## CCPS RFP#25-04 – NORTH EAST MIDDLE/HIGH SCHOOL REPLACEMENT PROJECT

### ADDENDUM #7

**This addendum is to provide the pre-bid agenda and attendance list and issued revisions to the contract documents as noted below.** Proposers and related parties will be responsible for reading and understanding all documents, the scope of work, addenda and all related solicitation documents issued. These documents will become attached to and part of the solicitation and award of bid contract.

1. **ASIs 01 and 02**
2. **PR 01**
3. **CLOSED RFIs 001- 0027, 029-031, 034. (open RFIs are excluded)**

**S103B**  
12/22/2023  
BID SET

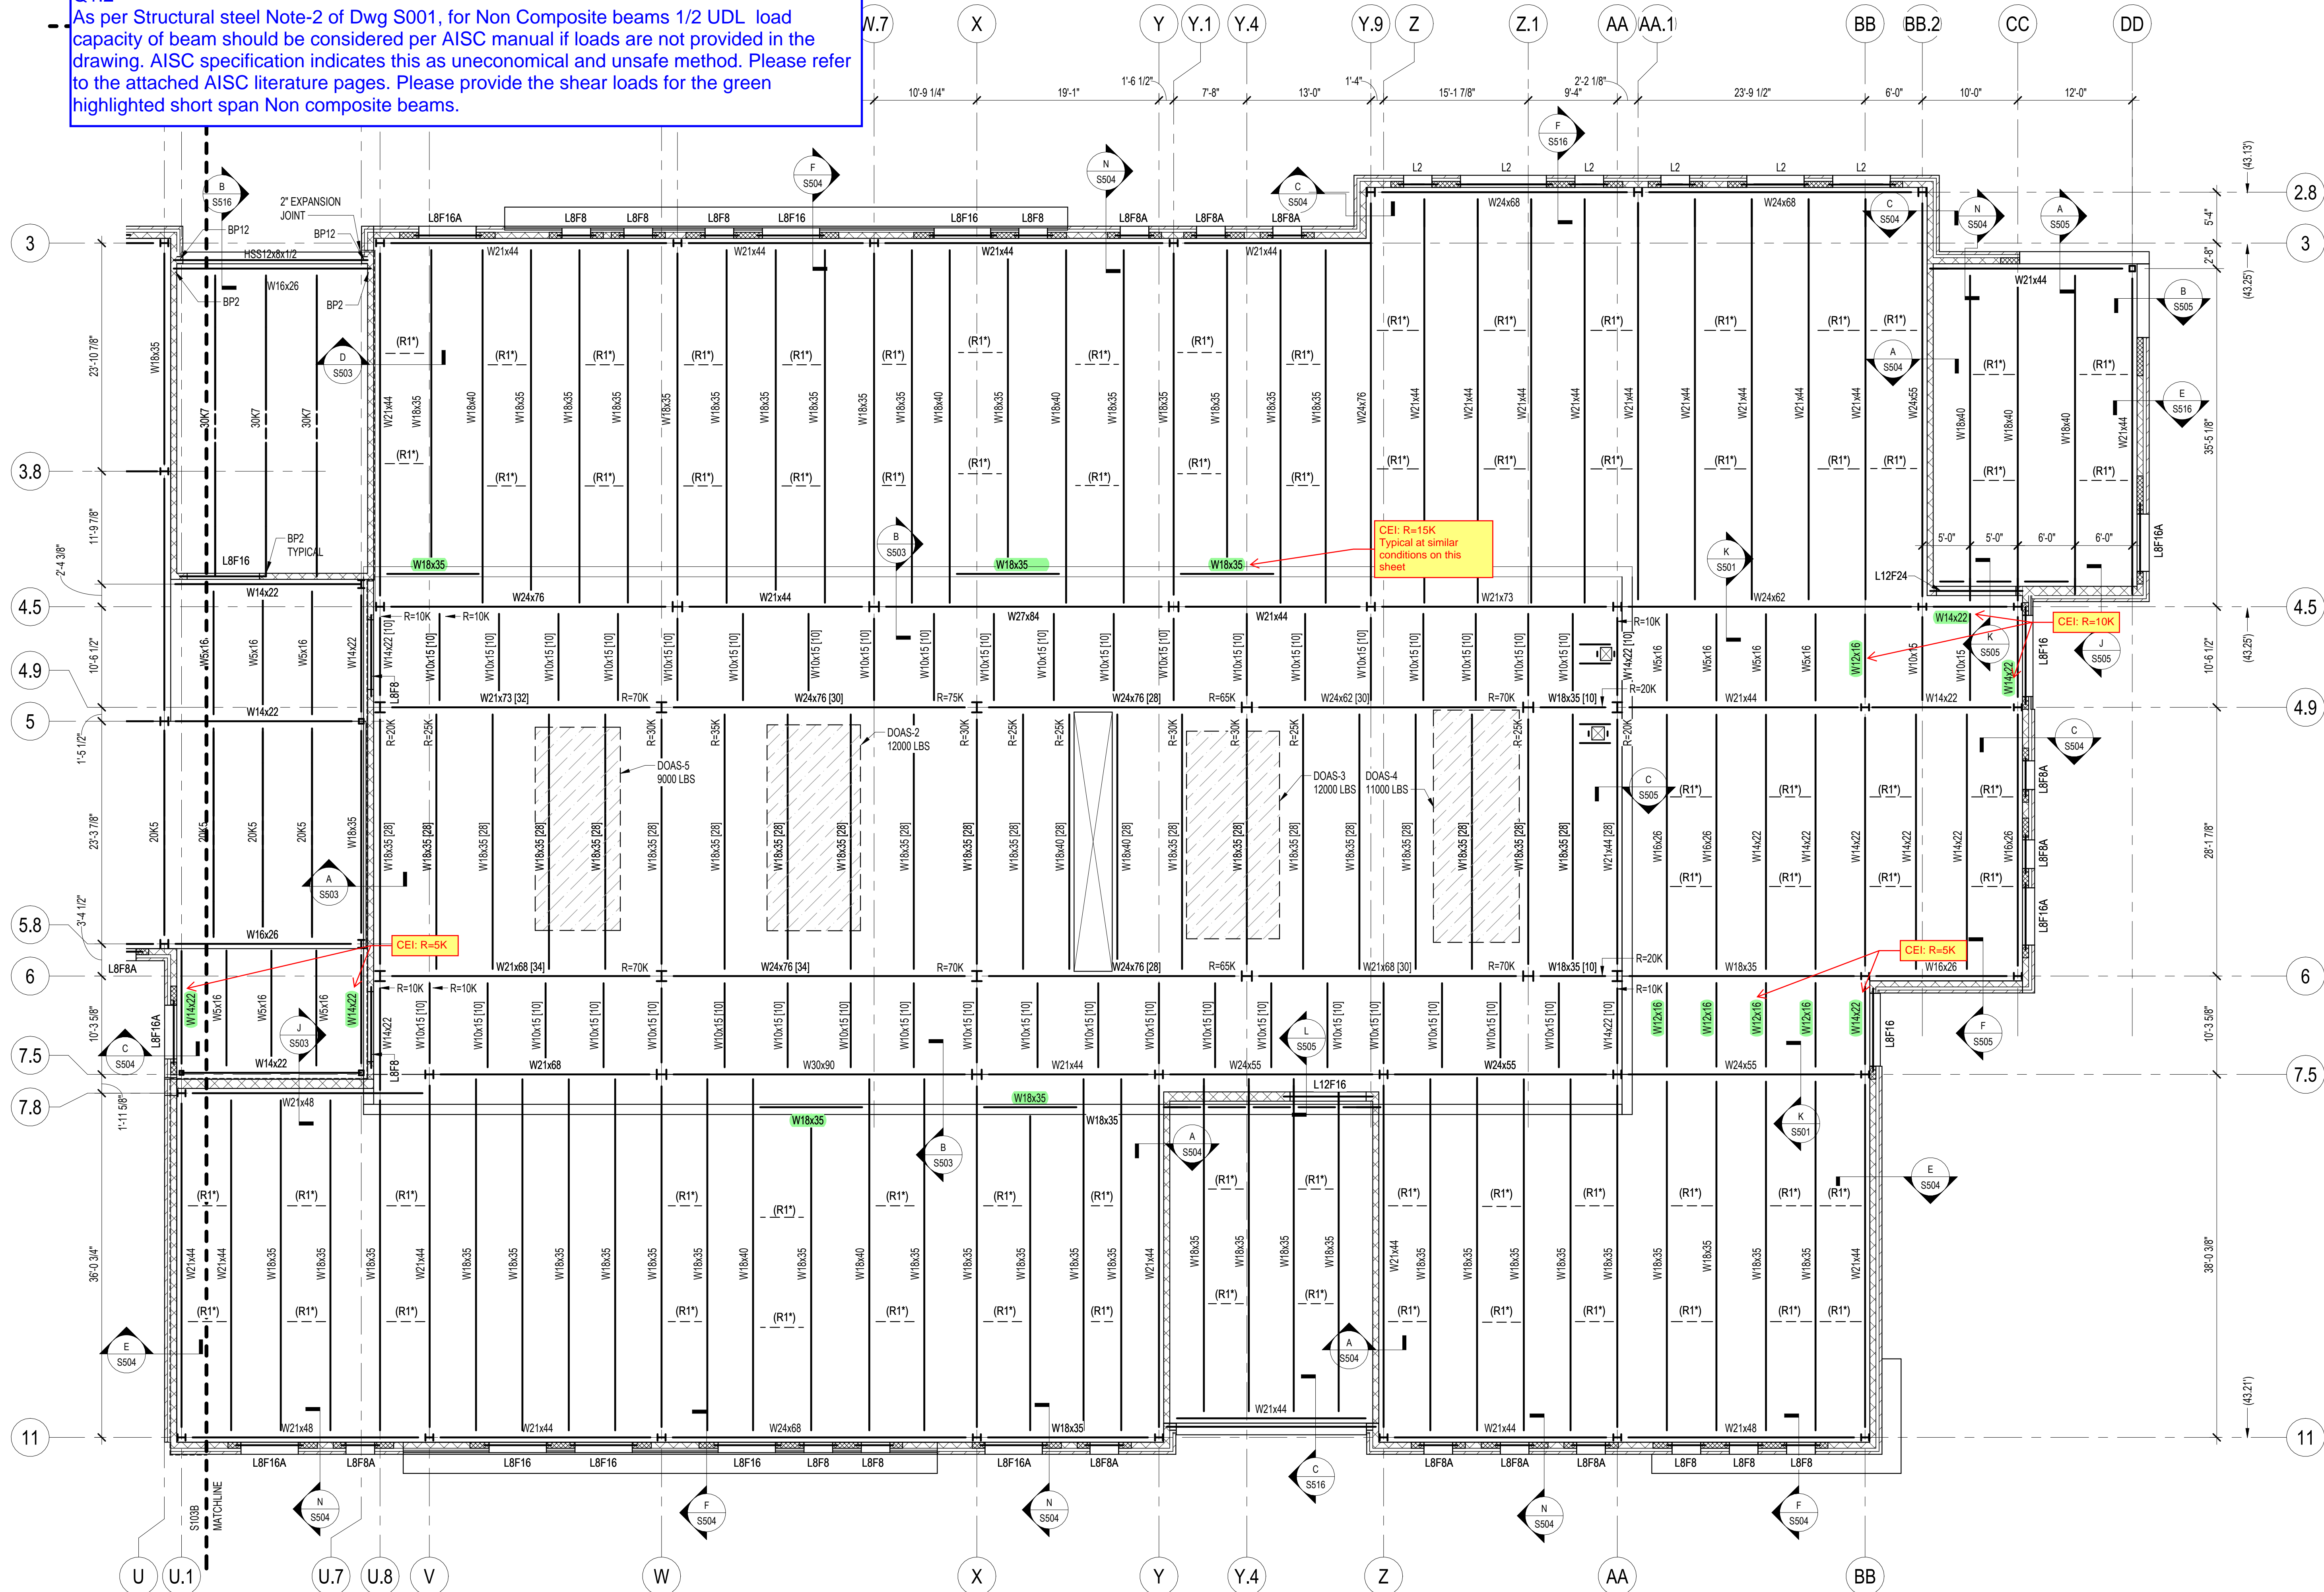
Q1.2  
As per Structural steel Note-2 of Dwg S001, for Non Composite beams 1/2 UDL load capacity of beam should be considered per AISC manual if loads are not provided in the drawing. AISC specification indicates this as uneconomical and unsafe method. Please refer to the attached AISC literature pages. Please provide the shear loads for the green highlighted short span Non composite beams.

S103C  
12/22/2023  
BID SET

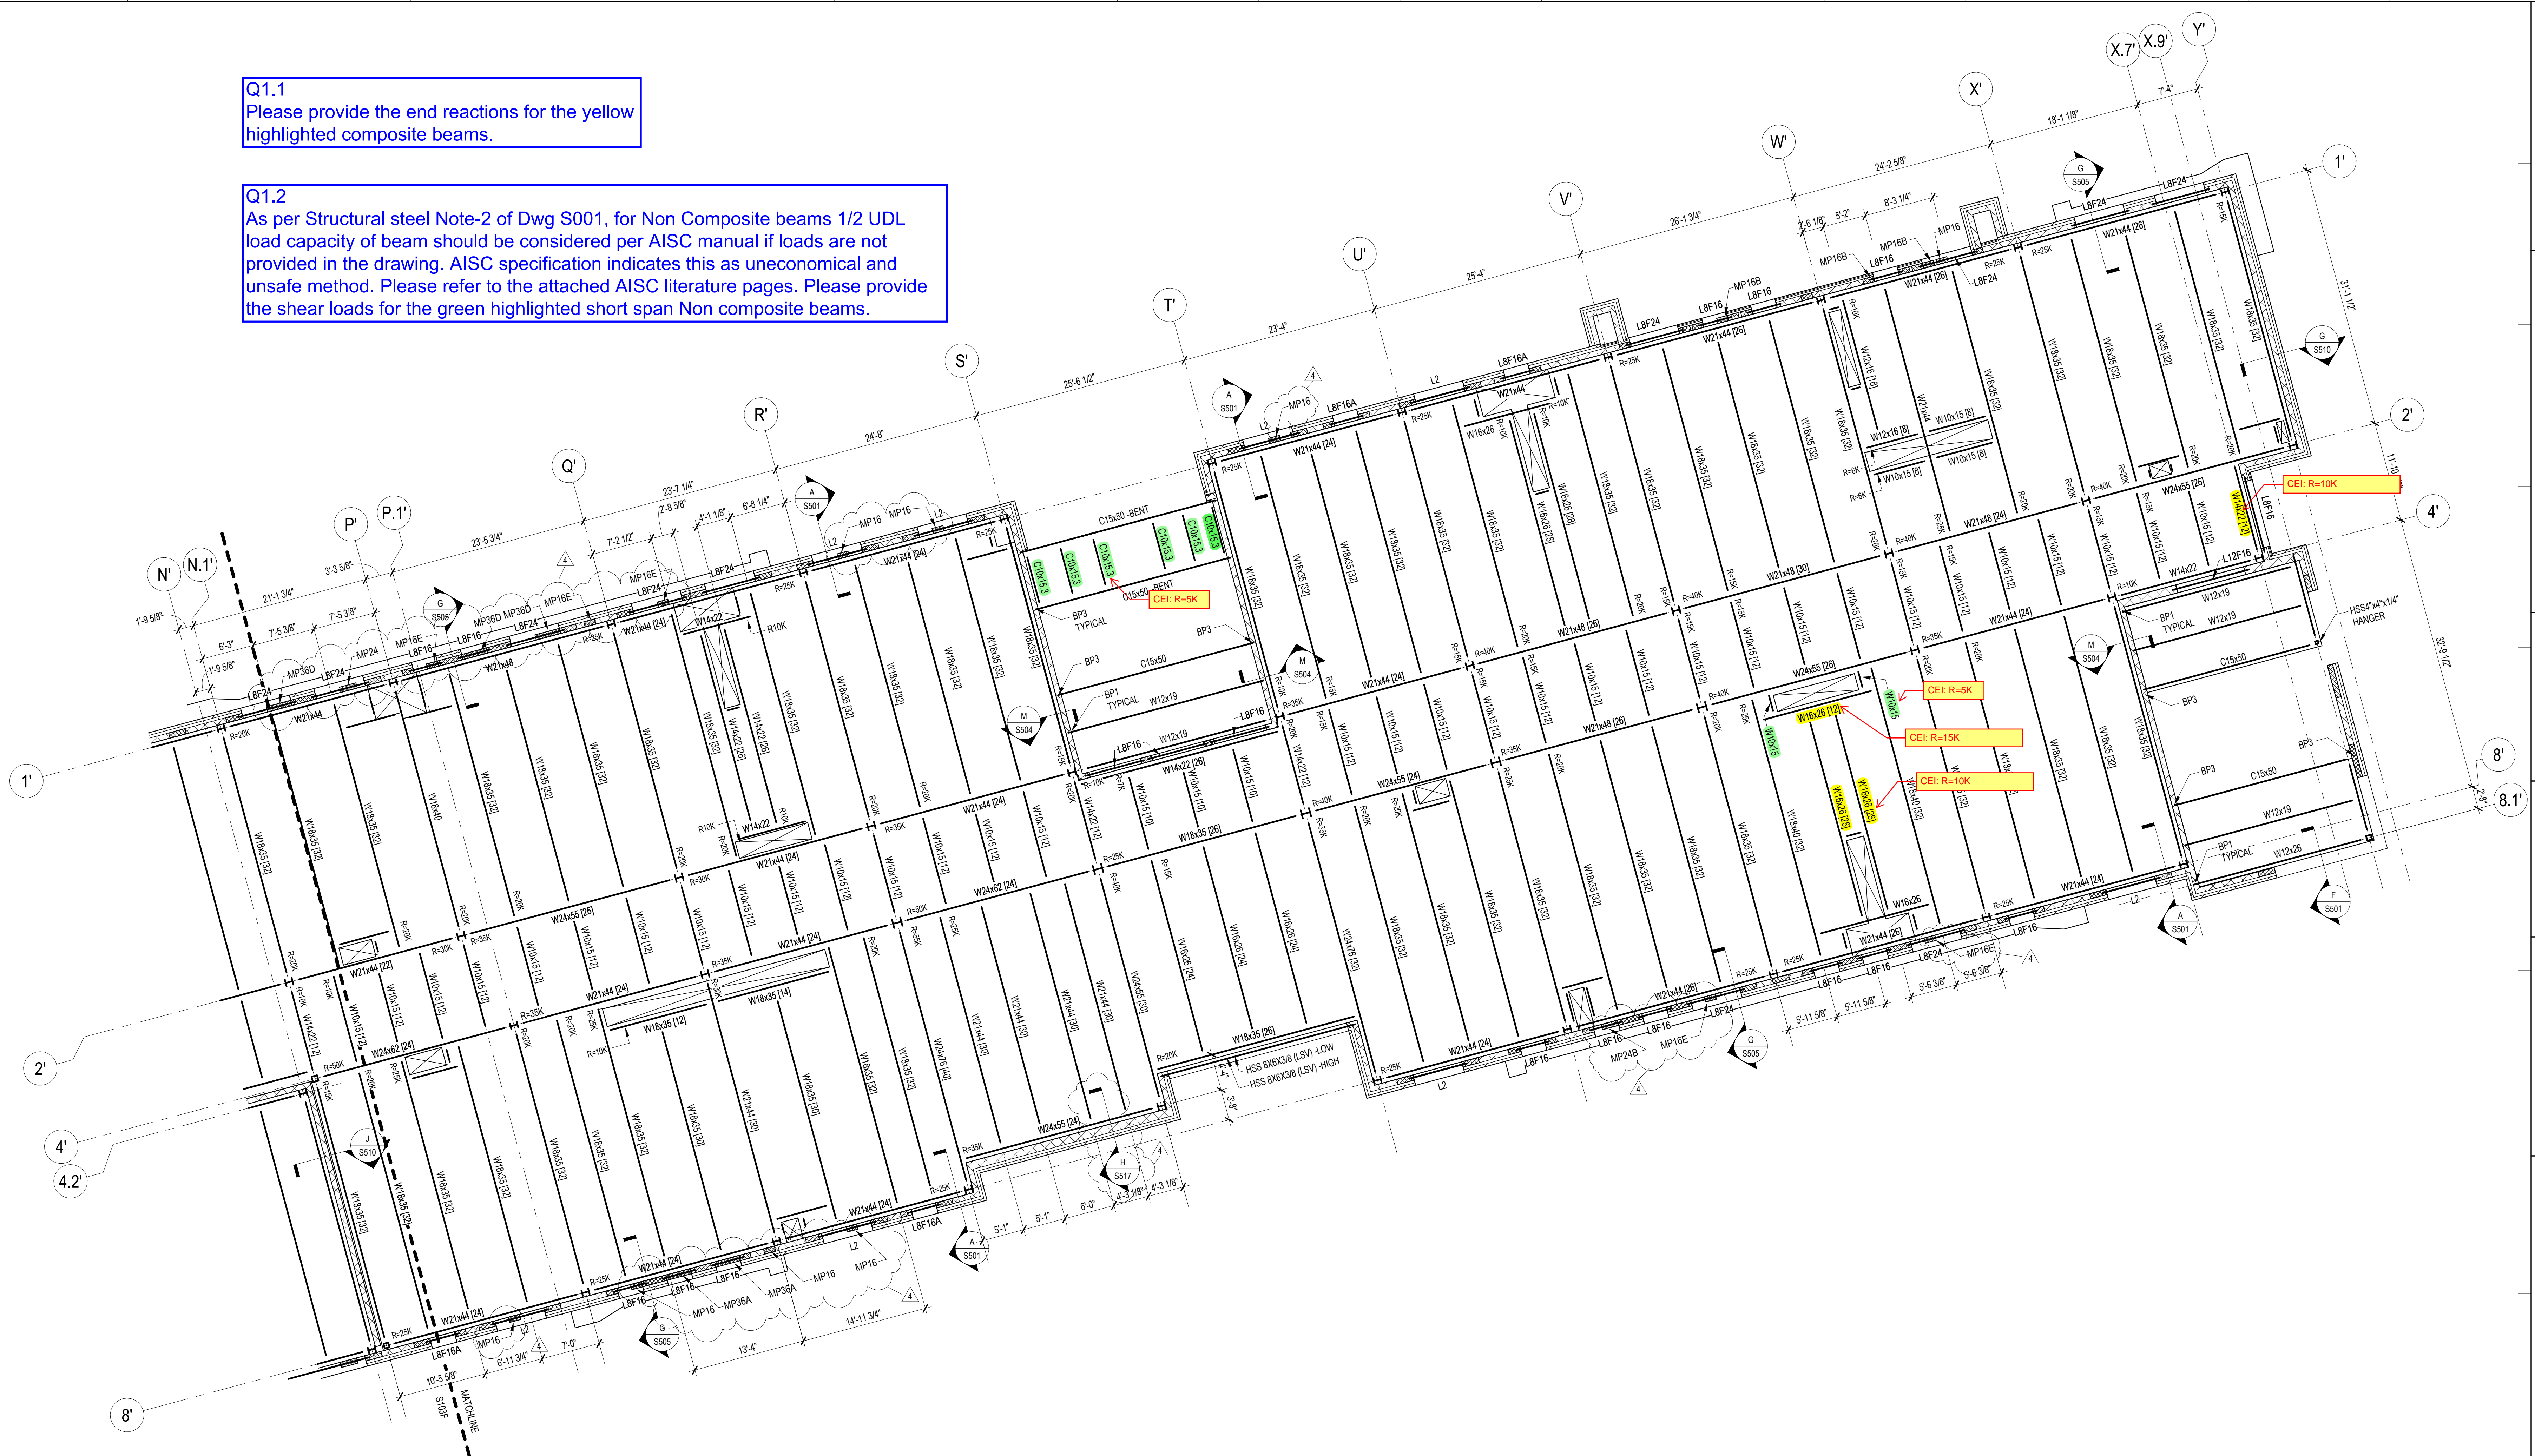
**Q1.2**  
As per Structural steel Note-2 of Dwg S001, for Non Composite beams 1/2 UDL load capacity of beam should be considered per AISC manual if loads are not provided in the drawing. AISC specification indicates this as uneconomical and unsafe method. Please refer to the attached AISC literature pages. Please provide the shear loads for the green highlighted short span Non composite beams.

### PENTHOUSE FLOOR AND ROOF FRAMING PLAN AREA G

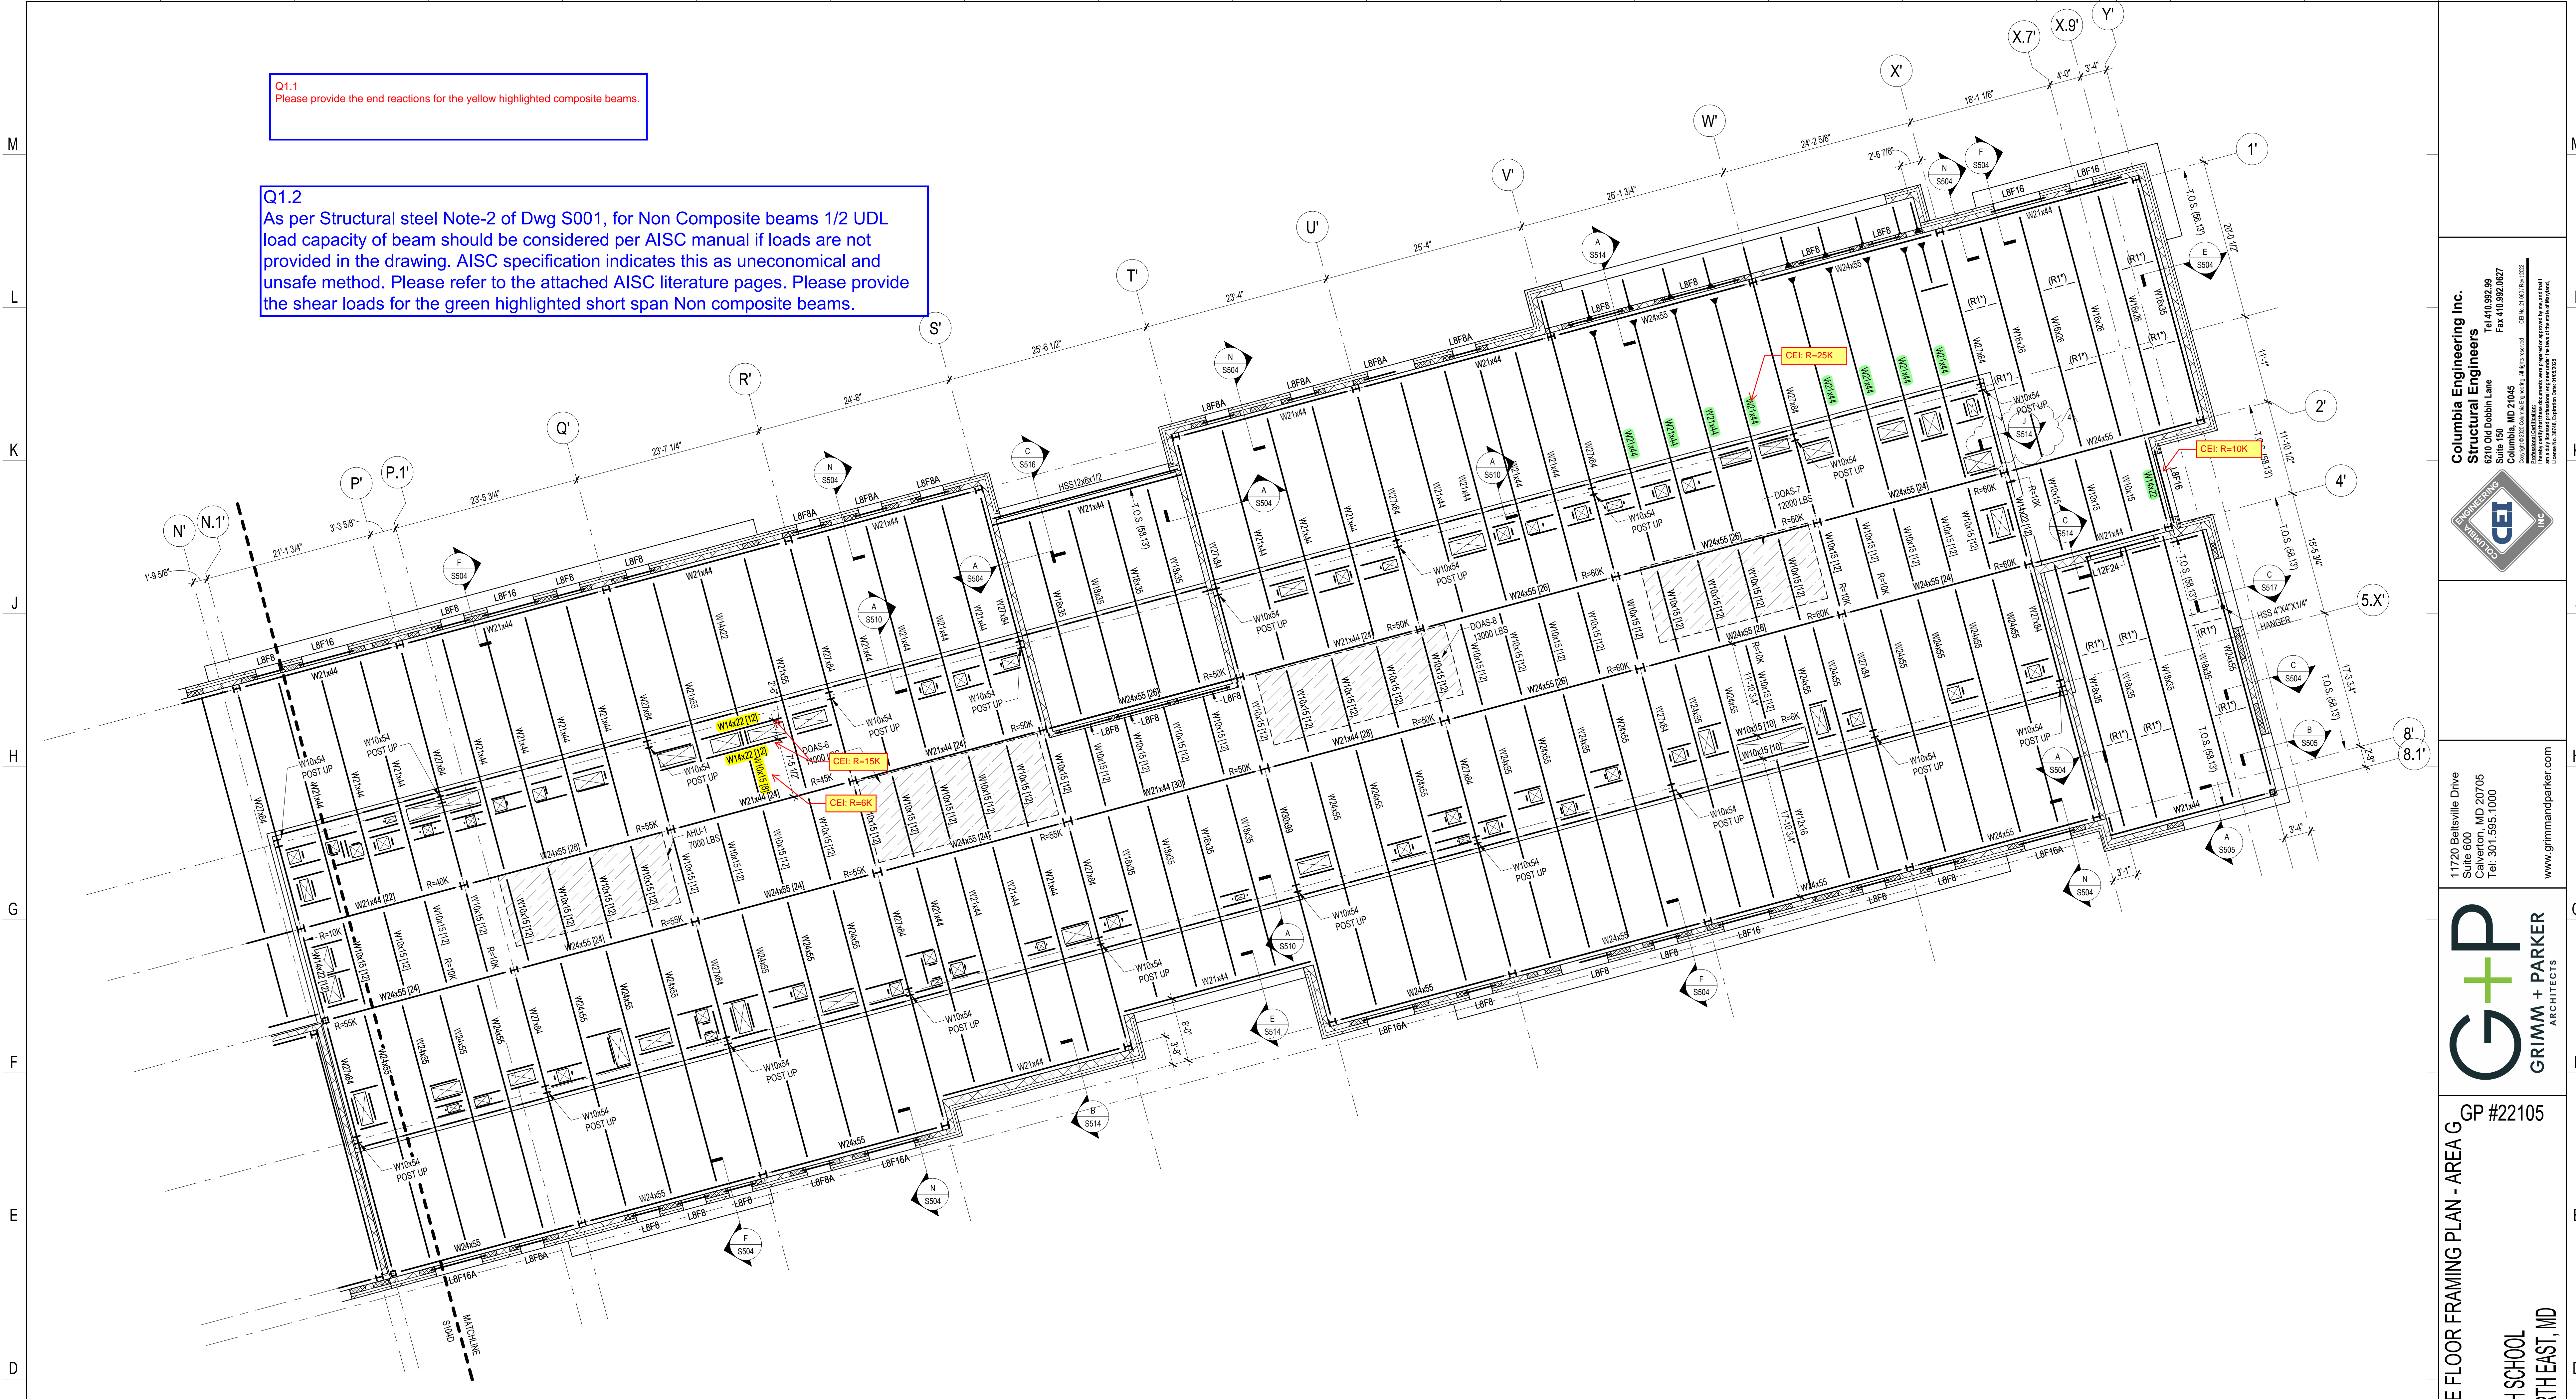
Q1.1  
Please provide the end reactions for the yellow highlighted composite beams.

Q1.2  
As per Structural steel Note-2 of Dwg S001, for Non Composite beams 1/2 UDL load capacity of beam should be considered per AISC manual if loads are not provided in the drawing. AISC specification indicates this as uneconomical and unsafe method. Please refer to the attached AISC literature pages. Please provide the shear loads for the green highlighted short span Non composite beams.
